**NOTICE OF ADDENDUM
ADDENDUM 1**

CONTRACT NO. 7928

**2017 PARKING
 GARAGE
 MAINTENANCE**

STATE STREET
 CAMPUS - FRANCES

**LEVEL 5
 FLOOR PLAN**

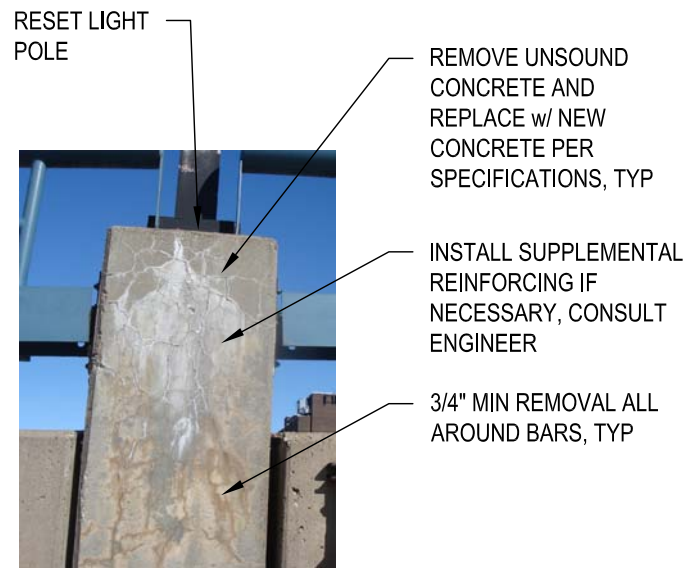
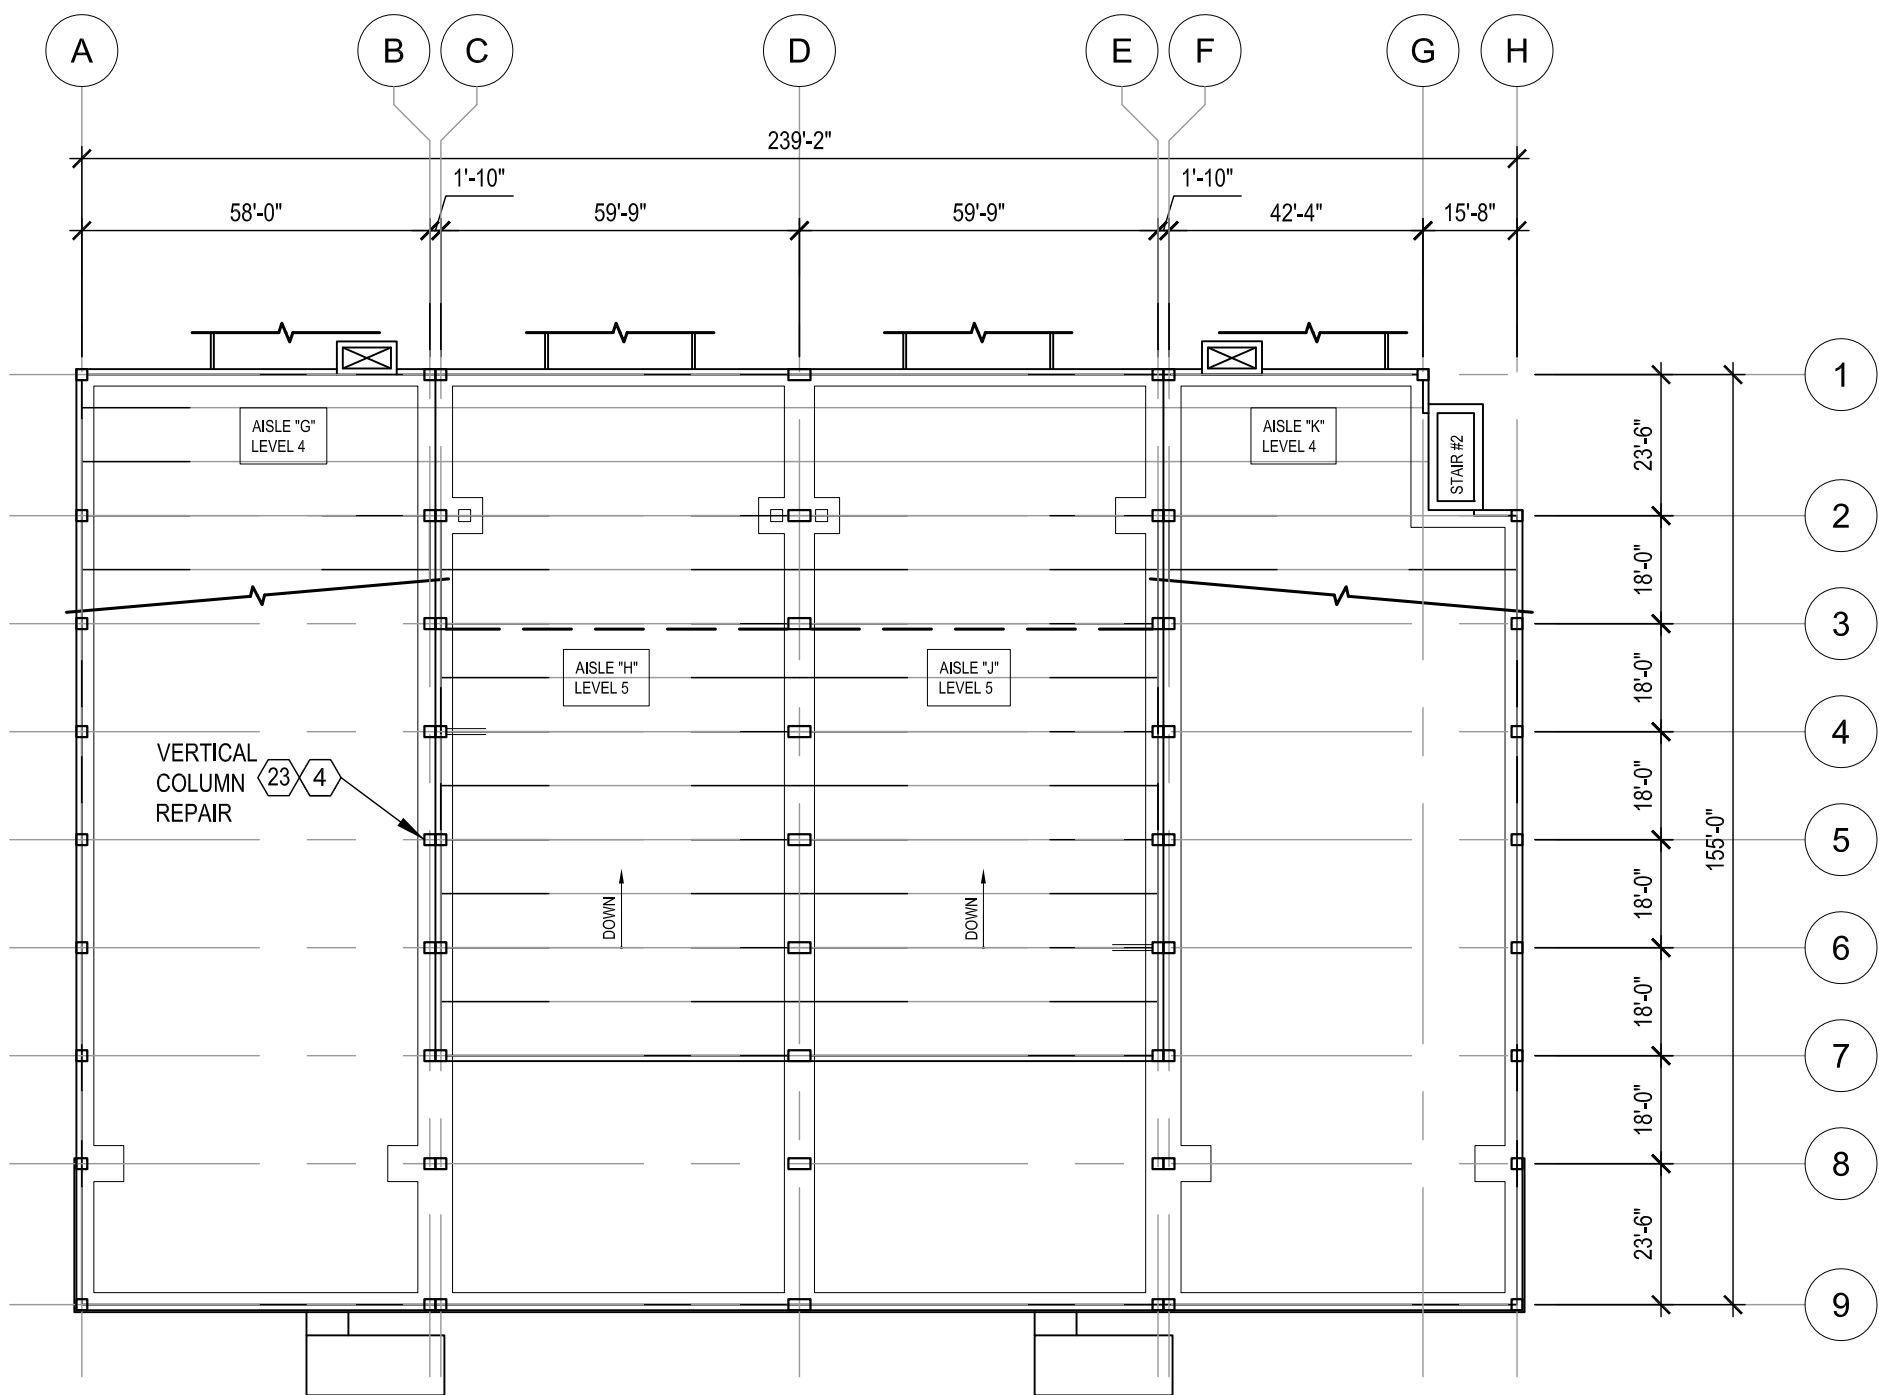
1. **SHEET SF2 - LEVEL 5 FLOOR PLAN:** Add to drawing set - vertical repair at column on the top level.
2. **SHEET SF3 - GRADING AND UTILITY PLAN:** Add to drawing set - civil design drawing for site improvements North of State Street Campus - Frances ramp.
3. **SHEET CNO - LEVEL L FLOOR PLAN:** Added an overhead beam repair at Northeast corner of Ramp.
